Dr. JORAM HOPENFELD

Demonstration of Flawed Presentation of CHECWORKS Data

Figure 2a:

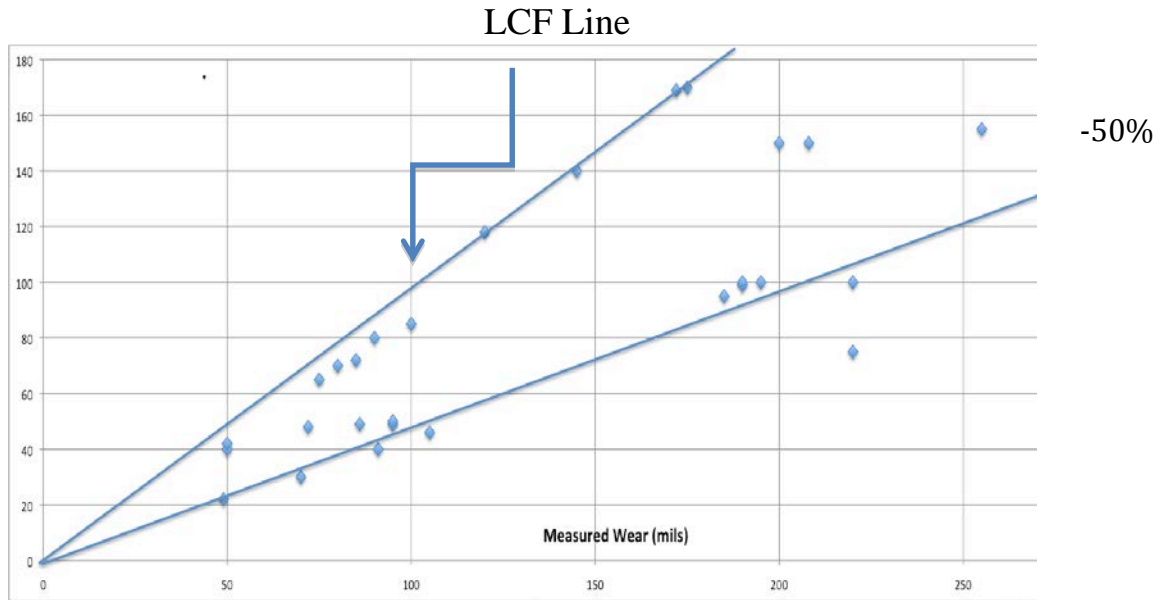
The non-conservative area of Figure 1 is re-plotted for comparison with Figure 3b below. Predicted wear on the y axis, measured wear on the X-axis. Top line is the LCF=1.060 line:
